## **BAMx Comments on the CAISO Draft 2012-13 Transmission Plan**

The Bay Area Municipal Transmission group (BAMx)<sup>1</sup> appreciates the opportunity to comment on the Draft CAISO 2012-13 Transmission Plan (Draft Plan) dated February 2, 2013, which was discussed during the Stakeholder meeting on February 11, 2012. The comments and questions below address both the Draft Plan and the February 11<sup>th</sup> Stakeholder meeting. We hope that the CAISO addresses these issues in its Final 2012-13 Transmission Plan.

**Figure 1: Estimated Economic Benefits of the Two Economic Study Projects Under Multiple CAISO Findings**

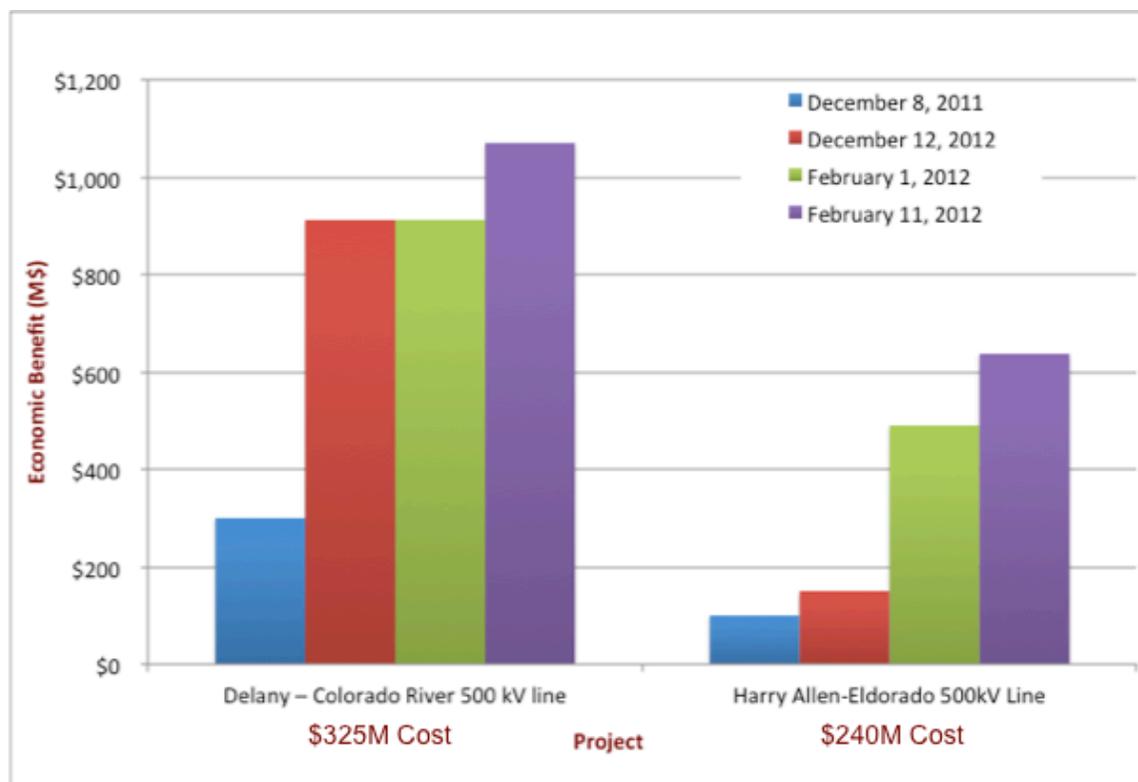
The Draft plan has recommended the *Delany – Colorado River 500 kV line* project for approval and has recommended the *Harry Allen – Eldorado 500 kV line* project for further study in the ongoing CAISO-NVE joint study. We have noticed that the estimated benefits associated with these two projects have gone up significantly under multiple CAISO reporting since last year as shown in Figure 1 below. The CAISO has provided little documentation in the Draft Plan on the reasons for such major changes in estimated benefits associated with these transmission projects. We request that the CAISO provides justification for these changes as well as arguments, if any, on why the final benefits calculations that were presented in the February 11th stakeholder meetings should be trusted to approve transmission projects costing hundreds of millions of dollars.

Furthermore, we find that the Net Present Value (NPV) calculations of the benefits of the candidate transmission projects to be questionable. For example, for the *Harry Allen – Eldorado 500 kV line* project, the CAISO calculated the total benefits in years 2017 and 2022 as **\$87M** and **\$33M**, respectively. Our understanding is that the CAISO interpolated these benefits for the intervening years and extrapolated the benefit of \$33M in years 2023 onwards at 1% annual escalation. We question the CAISO’s rationale for such extrapolation of economic benefit. The CAISO has estimated the NPV of benefits over 50 years discounted at 7% to be **\$637M**. We have verified these calculations. However, when we apply a trend on the benefits to extrapolate them beyond 2022 taking into account a significant drop in the benefits from 2017 to 2022, we get a NPV of benefit of **\$327M** over 50 years, nearly half as much as benefit calculated by the CAISO.<sup>4</sup> This exercise demonstrates that the CAISO’s calculation of the benefits based on only two years of data is highly susceptible to how the extrapolation of these benefits are calculated. BAMx believes that it is important to recognize why the benefit has dropped from 2017 to 2022, the likely reason being the increased buildup of the low variable cost renewables within the CAISO BAA. If the renewable buildup continues to go up within the CAISO in the later years, it is likely that the benefit of the out-of-state (OOS) transmission projects like *Harry Allen – Eldorado 500 kV line* will go down.

It also is important to recognize the calculated benefits assume the completion of other projects whose construction is uncertain. We urge the CAISO to continue its study of the potential benefits of projects that can import power from other States but to not approve them in this transmission planning cycle.
